# **The Northwood Action Group Inc**

### **Subject: Objection to Redevelopment of Greenwich Hospital (Concept Proposal) SSD 17\_8699**

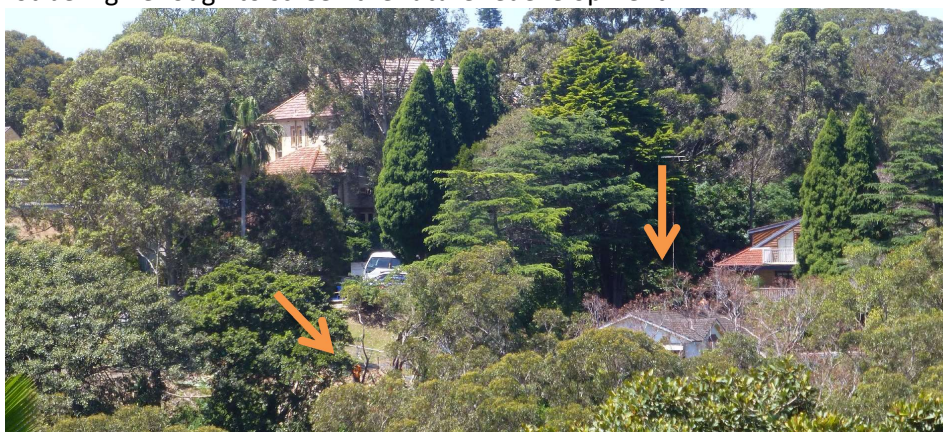
The raised new internal road, the podium at RL44 and the 6 stories of apartments in two blocks will increase noise and lighting impacts, and present massive walls of windows and balconies (mostly full width of each apartment) – facing, and close to, parts of Northwood.

Privacy loss. Residents have raised privacy concerns about this privacy intrusion by many eyes, and by lights. It is observed that current floodlighting at the western side of the 5 storey main building intrudes into homes during the dark of night. Many lights and external lights will add to light spill, as will vehicle headlights and necessary outdoor and safety lighting.

The acoustic report has not considered Northwood at all in its assumption of noise-affected properties. Noise travels across the valley easily, impact noise is especially noticeable at quieter times, or when the wind assists travel of sound waves. Residents with direct line of sight have complained of loud noises from hospital operations at times, and in particular being woken in the wee hours by garbage truck skip collection processes. The acoustic report completely fails to mention this noisy operation, or in the alternative, dismisses it with the EPA quote that one or two incidents per night are "unlikely to affect health and wellbeing". The places where the noise monitors have been placed are low down in troughs in the ground terrain and behind trees, so are not regarded as appropriate monitors of typical noise because of the screening effect on sound waves. High walls, of hard surfaces, are noise reflective surfaces, will increase noise generation and reverberation.
